## ORIGINATION FORM

### Proposed Revisions to a Standard Plans Index

Index Number: 700-041

Index Title: Span Sign Structure

LAST REVISION	11/01/22	DESCRIPTION:		FY 2022-23 STANDARD PLANS	SPAN SIGN STRUCTURE	INDEX 700-041	SHEET 1 of 5
---------------	----------	--------------	--	------------------------------	---------------------	------------------	-----------------

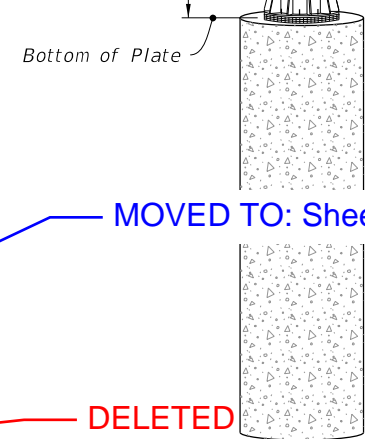
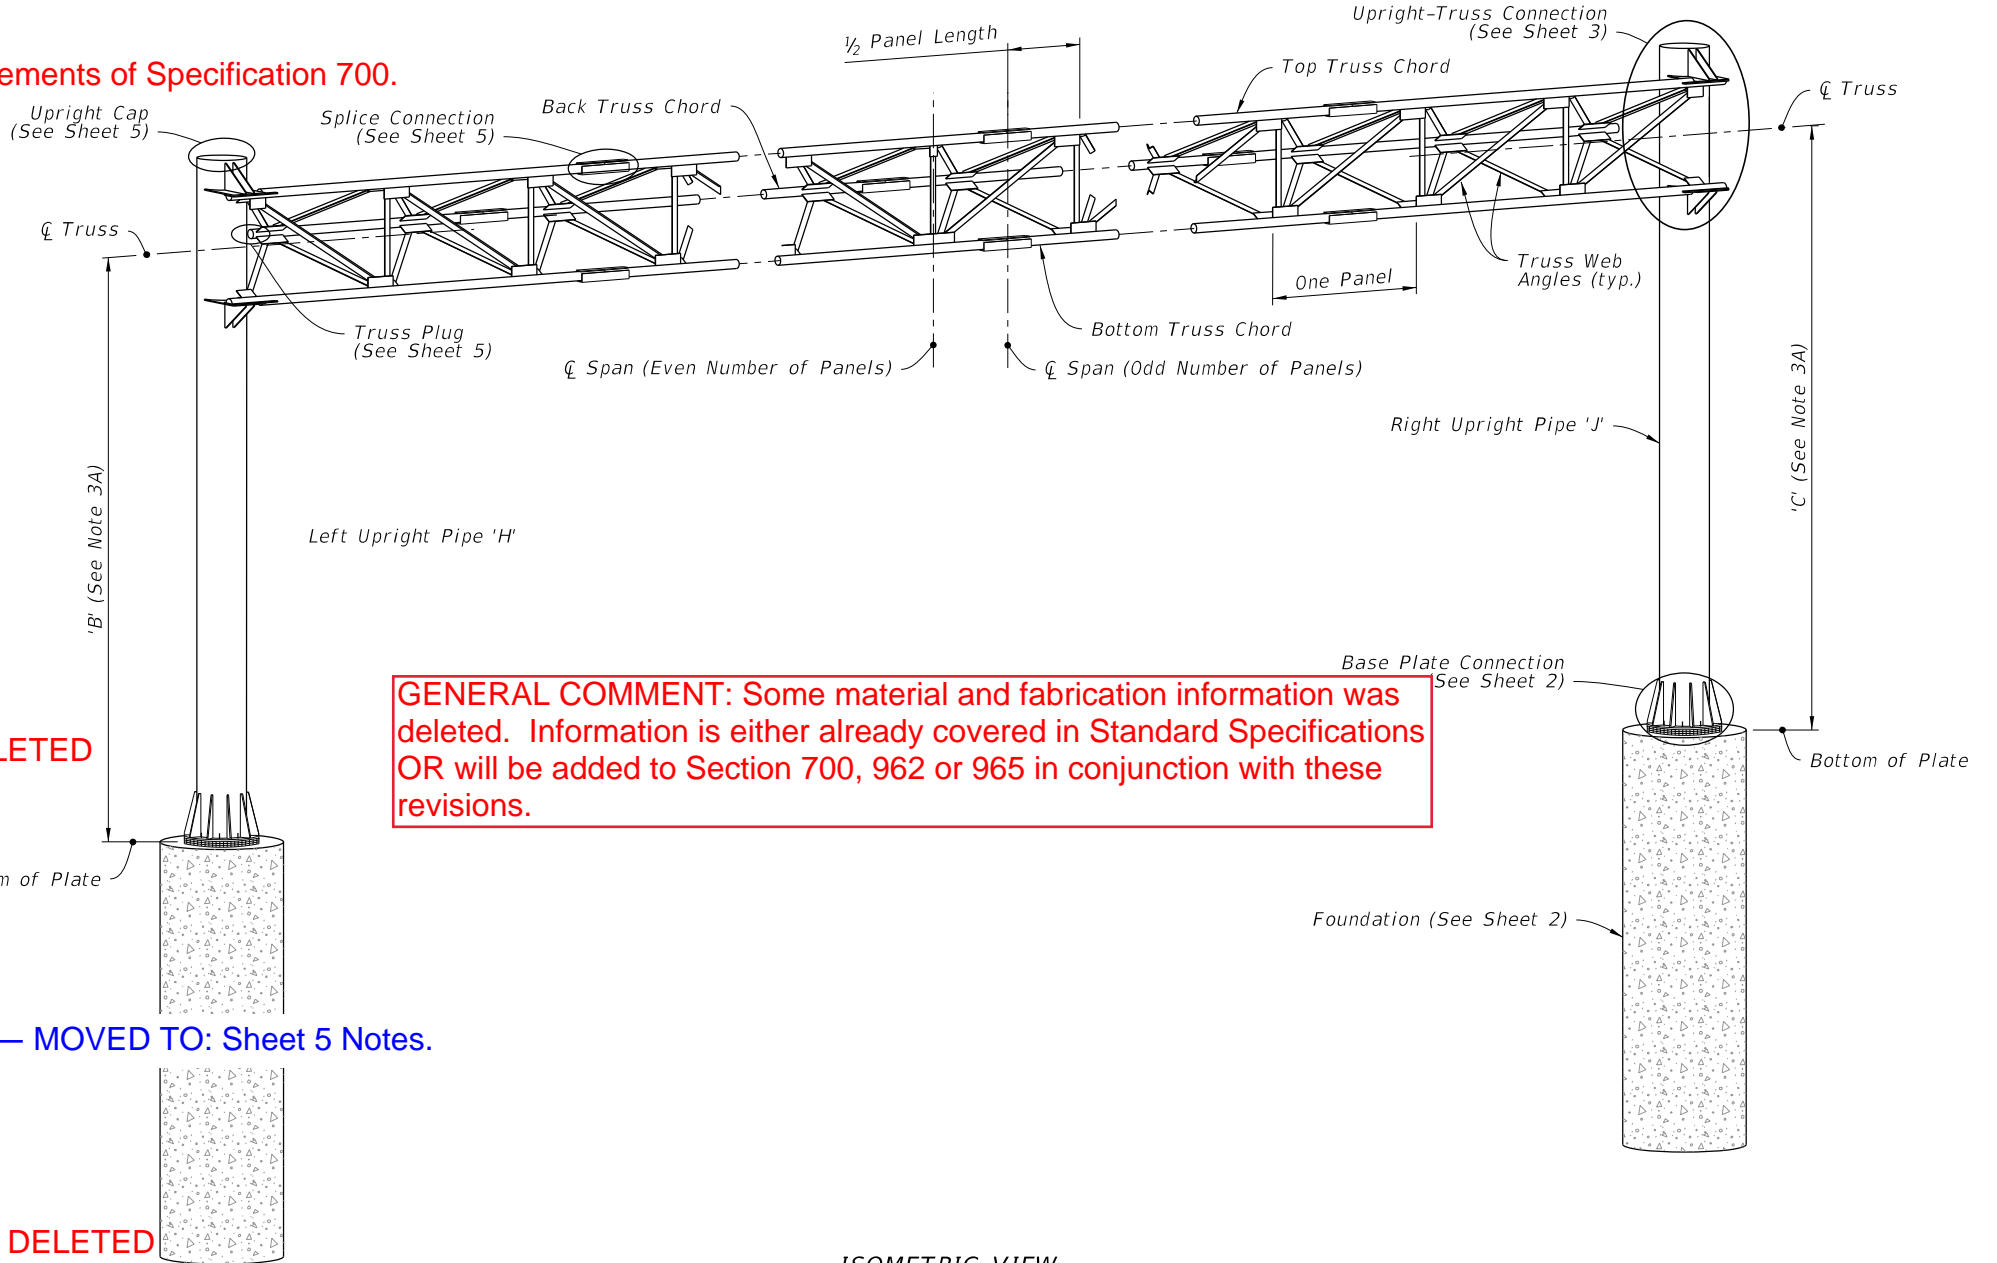
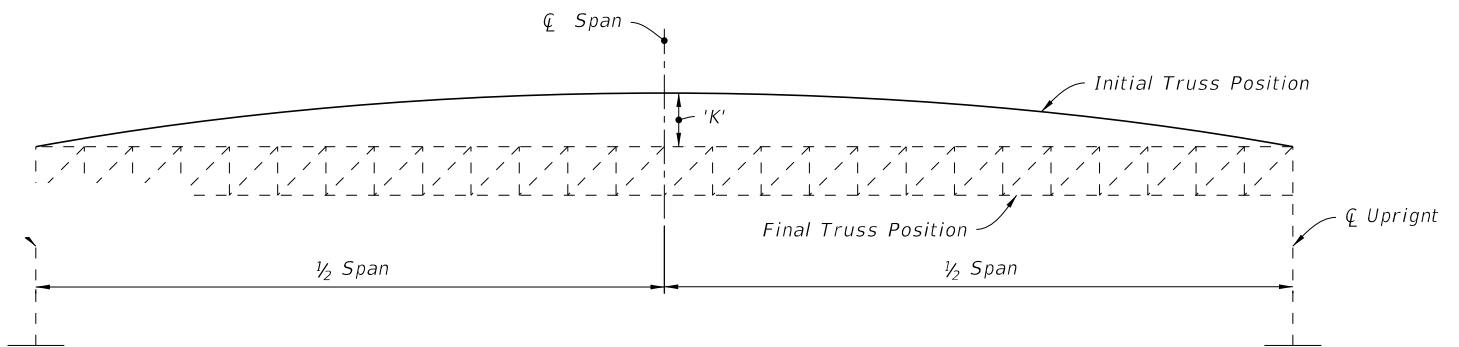
Sheet 1: Updated Notes to General Notes; Added New General Note 1 - "Meet the requirements of Specification 700"; Deleted Notes 4 through 7; Moved Note 5.B and 5.C to Sheet 5 Notes; Renumbered Notes.

**ADDED NEW NOTE 1: Meet the requirements of Specification 700.**

**UPDATED: GENERAL NOTES:**

- 2. ~~Work this Index in conjunction with SPAN SIGN STRUCTURE DATA TABLES in the Plans and Index 700-030.~~
- 3. ~~Handholes at the pole base are required for DMS Structures. Refer to Index 700-090 for Handhole Details.~~
- 4. ~~Shop Drawings are required.~~

**DELETED**

**MOVED TO: Sheet 5 Notes.**

**DELETED**

**DELETED**

**GENERAL COMMENT: Some material and fabrication information was deleted. Information is either already covered in Standard Specifications OR will be added to Section 700, 962 or 965 in conjunction with these revisions.**

BASE PLATE CONNECTION

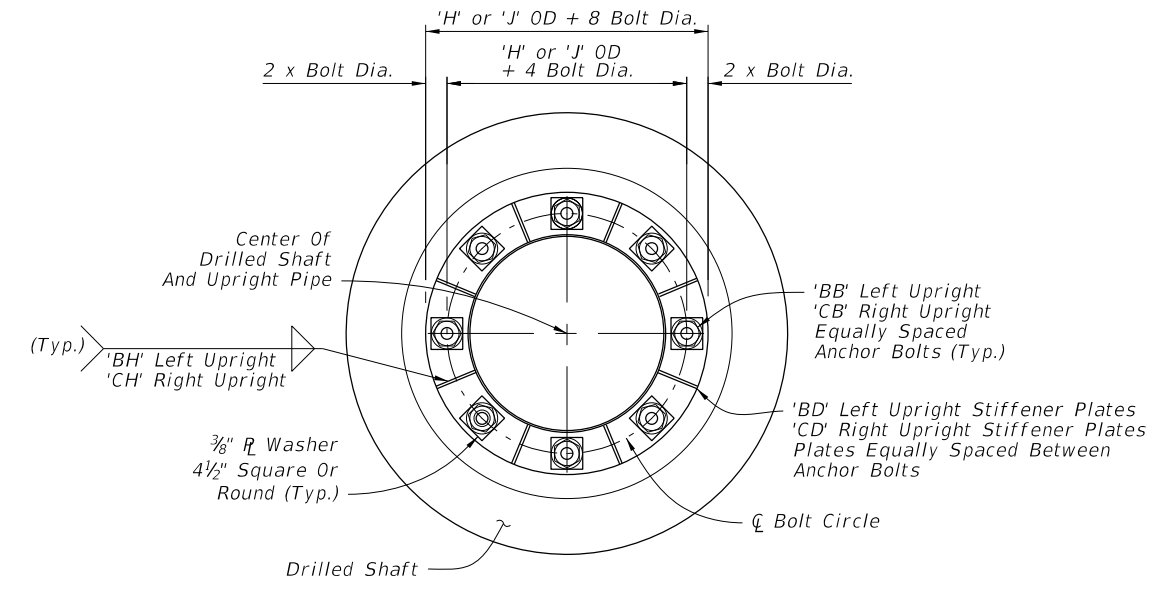
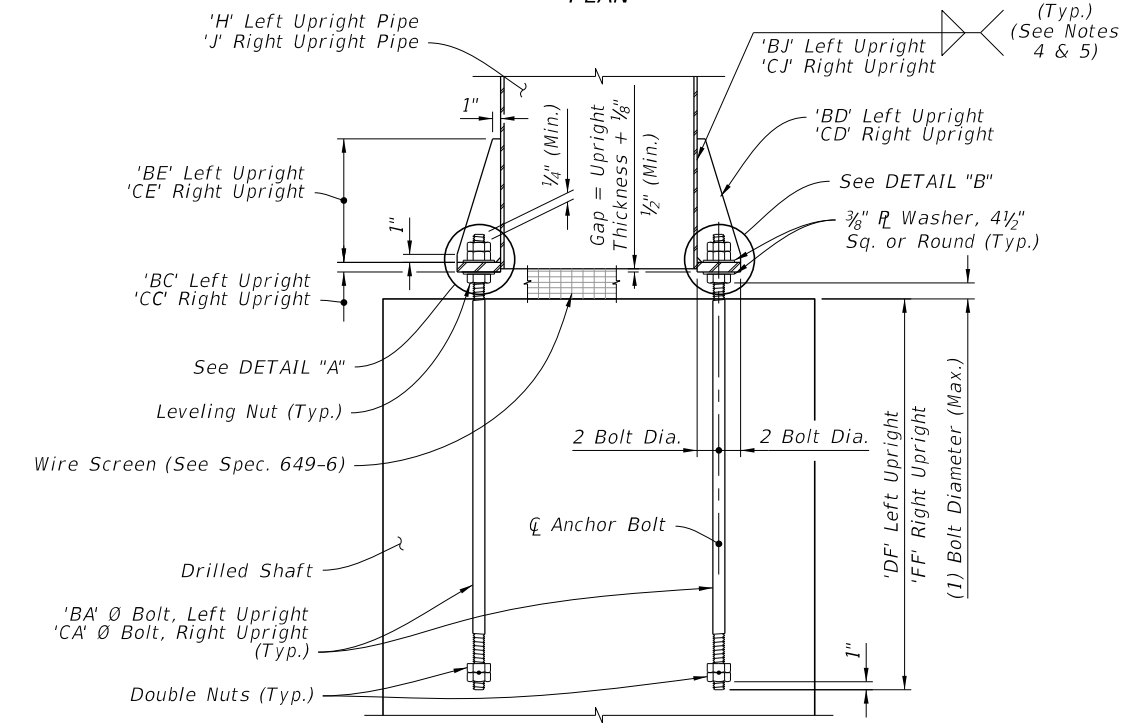
Sheet 2: Added note 6 detailing the weld pattern of the 'BD' and 'CD' plates indicating that they should be welded in a star pattern.

Sheet 2: This process is to help prevent residual stress buildup in base plate connection to prevent cracking.

**6.** **ADDED NOTE 6: 6. Weld plates 'BD' and 'CD' in a star pattern. A star pattern is one in which the plates on opposite and near opposite sides of the pole circle are successively welded in a pattern resembling a star. For an 8 plate circle with plates sequentially numbered 1 to 8, weld the plates in the following order: (1, 5, 7, 3, 8, 4, 6, 2).**

**SPLICE CONNECTION NOTE:**

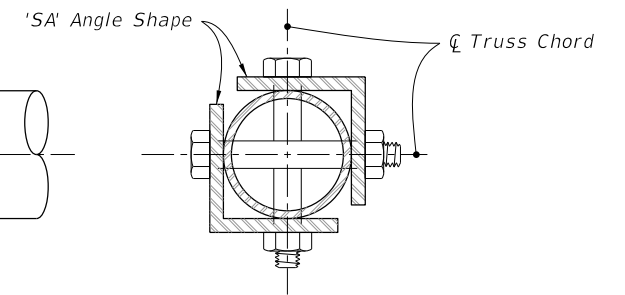
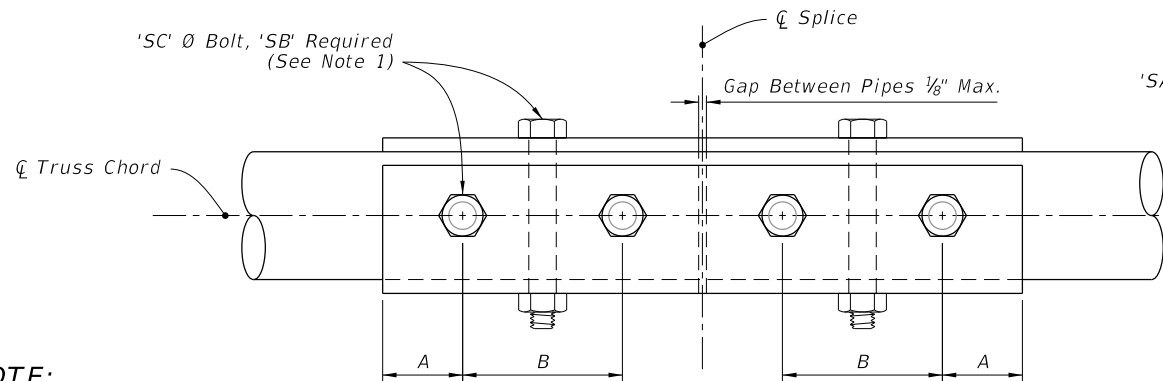
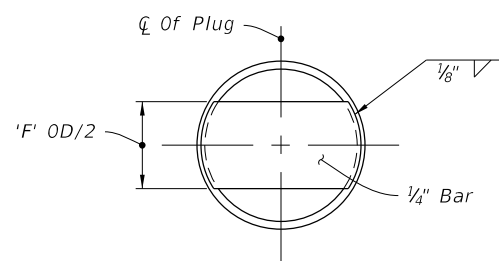
Sheet 5: Added General Note 5.B and 5.C as New Note 2 - "Chord Splices: Minimum splice spacing is three truss panel lengths apart and three truss panel lengths from the uprights when panel lengths are 10'-0" or less. Chord Splices may be either the Standard Splice or the Alternate Splice, but not both on the same structure." and Note 3 - "Upright splice: Not allowed unless the upright exceeds available mill lengths (35' - 40')."

**ADDED NOTES 2 AND 3:**

- 2. Chord Splices: Minimum splice spacing is three truss panel lengths apart and three truss panel lengths from the uprights when panel lengths are 10'-0" or less. Chord Splices may be either the Standard Splice or the Alternate Splice, but not both on the same structure.
- 3. Upright splice: Not allowed unless the upright exceeds available mill lengths (35' - 40').
